Access Compliance Report

Public Rights-of-Way

(Curb Ramps)

Intersection ID: 10013252	Main Street: CRAIGHEAD_RD	Cross Street: N/A	Location: S
ADA ID: 2656919A3102	Ramp Type: BlendTrans1	Initial Pass/Fail: Fail	Overall Compliance: No
Severity Score: 12.5			
Codes/Mitigation Info/Possible Solution		Field Measurements/Component Compliance

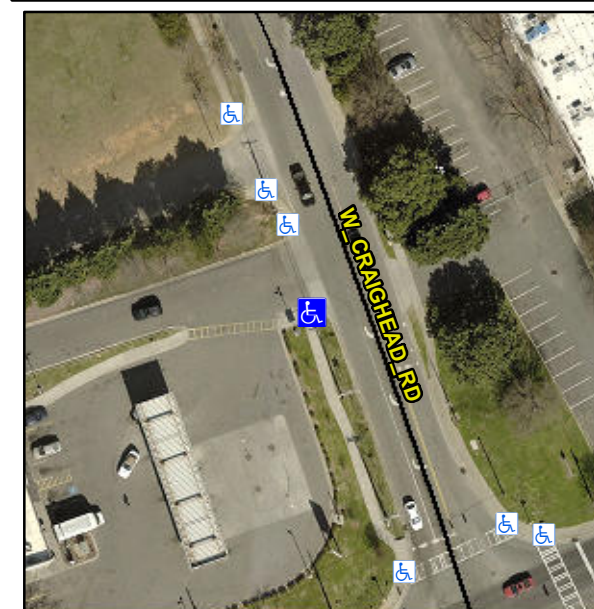
Not Found, R304.5.3

Compliance	Description	Data	Compliance	Description	Data
N/A	Ramp Length (in)	78.0	Yes	BlendTrans Slope (%)	4.9
Yes	Ramp Width (in)	48.0	No	BlendTrans XSlope (%)	5.5
N/A	Flare Type LT	N/A	N/A	Flare Type RT	N/A
N/A	Flare Slope LT (%)	N/A	N/A	Flare Slope RT (%)	N/A
N/A	Flare Traversable LT?	N/A	N/A	Flare Traversable RT?	N/A
N/A	Landing Length (in)	N/A	N/A	DWS Provided?	N/A
N/A	Landing Width (in)	N/A	N/A	DWS Contrast?	N/A
N/A	Landing Slope (%)	N/A	N/A	DWS Length (in)	N/A
N/A	Landing X Slope (%)	N/A	N/A	DWS Full Width?	N/A
N/A	Landing Curb? (Y/N)	N/A	N/A	DWS Offset (in)	N/A
N/A	Shared Landing?	N/A			
N/A	Gutter Ponding?	N/A	N/A	Gutter Slope (%)	N/A
N/A	Gutter Lip Ht (in)	N/A	N/A	Gutter X Slope (%)	N/A
N/A	Painted X Walk1?	No	N/A	Painted X Walk2?	No
	X Walk 1 Direction	To E		X Walk 2 Direction	To NW
	X Walk 1 Width (in)	N/A		X Walk 2 Width (in)	N/A
	X Walk 1 Slope (%)	3.5		X Walk 2 Slope (%)	3.4
	X Walk 1 X Slope (%)	2.6		X Walk 2 X Slope (%)	1.6

N/A	Ramp inside XWalk1?	N/A	N/A	Ramp inside XWalk2?	N/A
	Road Slope (%)	2.3		Clear Space?	N/A
	Road X Slope (%)	0.8	N/A	Clear Space to XWalk (in)	N/A
N/A	Any Obstructions?	N/A	N/A	Storm Grate/Utility Hazard?	N/A
	Obstruction Type			Storm Grate/Utility Type	
		N/A			N/A
			Yes	Surface Condition? (G/P)	Good
			No	Curb Slope (%)	12.0

Remove & Replace Curb Ramp With Two New Directional Ramps or Equivalent.
